**Subject** ▶ Change on screw

**For Models** ▶ 8412DWH (Cordless Percussion Driver Drill)

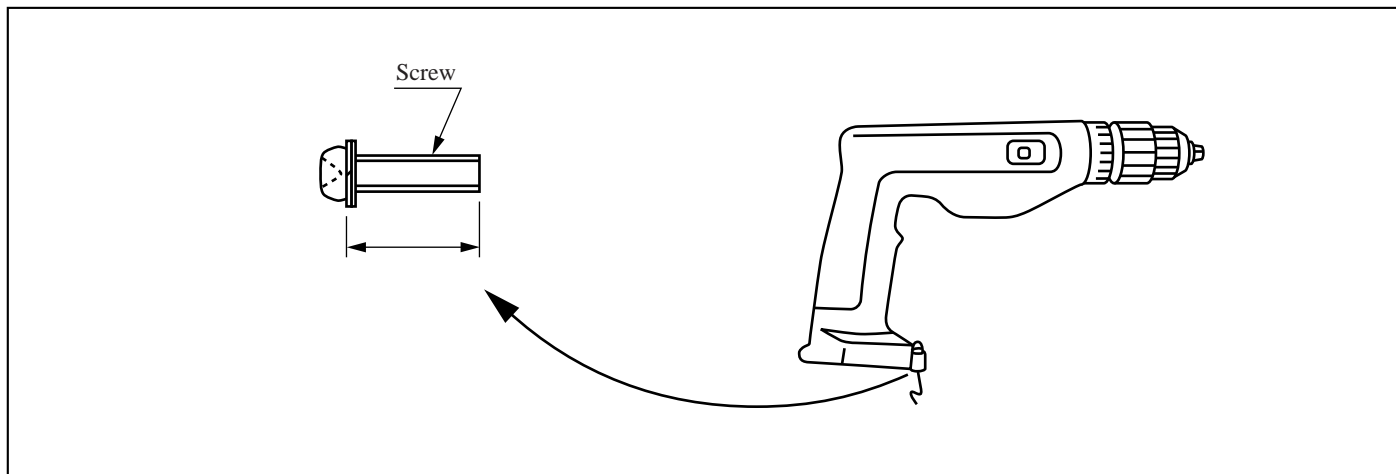
**Description** ▶ The screw which secures the set plate will be changed from 20 mm (25/32") to 22 mm (7/8") in length.

When replacing the housing, also replace the screw M4x20 by the screw M4x22.

Item No.	Current part		Q'ty	I/C	New part		Q'ty	Note
3	Screw M4x20 911138-5		1	<=	Screw M4x22 911143-2		1
